STAFF REPORT: APRIL 10, 2024 SPECIAL MEETING
APPLICATION NUMBER: HDC2023-00066
ADDRESS: 1180 VINEWOOD
HISTORIC DISTRICT: HUBBARD FARMS
APPLICANT: VALERIA LOPEZ
PROPERTY OWNER: VALERIA LOPEZ
DATE OF PROVISIONALLY COMPLETE APPLICATION: MARCH 23, 2024
DATE OF STAFF SITE VISIT: MARCH 28, 2024 **AND APRIL 5, 2024**

SCOPE: ALTER DWELLING INCLUDING WINDOW AND DOOR OPENINGS, ROOF, SIDING, AND PORCH (WORK COMPLETED WITHOUT APPROVAL)

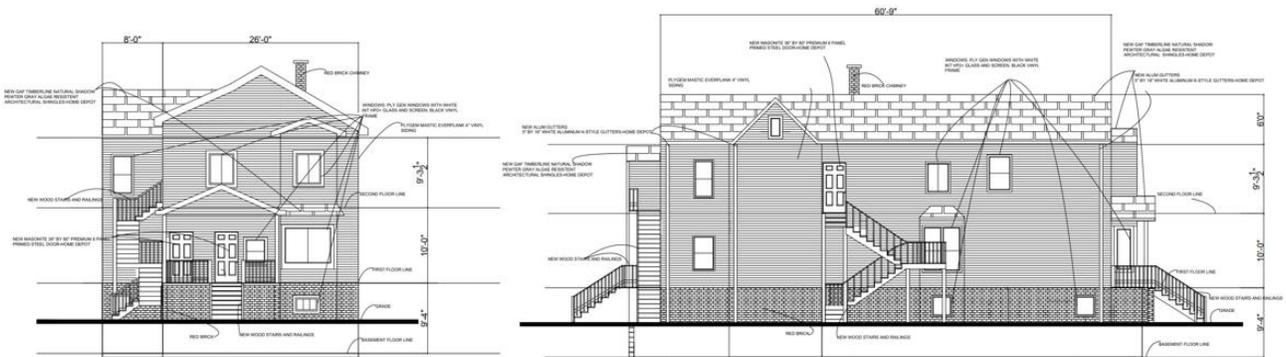
By the time of the Stop Work order, additional work had been done on the house. The porch is now removed entirely, replaced with a gable-roof porch. The remaining historic windows are removed, with vinyl slider and sash windows installed. The windows are trimmed with what appears to be aluminum or vinyl. The Classical trim on the north-facing bay window has been either removed or covered with a hip-roof projection.
